REMARKS

The Examiner's action of August 24, 2004 is noted in which the claims are rejected under 35 USC 102 and 103. Moreover, the Drawings are objected to for inclusion of a reference number for two separate elements.

Fig. 6

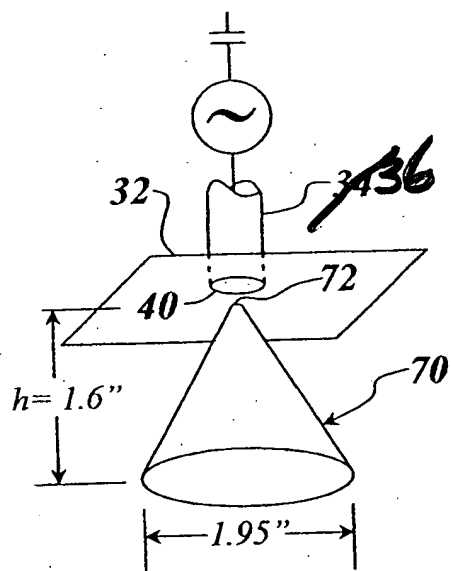
Applicant has amended Page 9, Line 20 to indicate that the conical surface is not "36" as indicated, but "37;" and has indicated same in the substitute drawing submitted herewith. Moreover, in a review of the Patent Application it was found that on Figure 6 there is a reference character error in that item "34" should in fact be item "36," to make it consistent with the remainder of the case.

The above changes are submitted herewith in a Letter to the Official Draftsman subject to Examiner's approval.
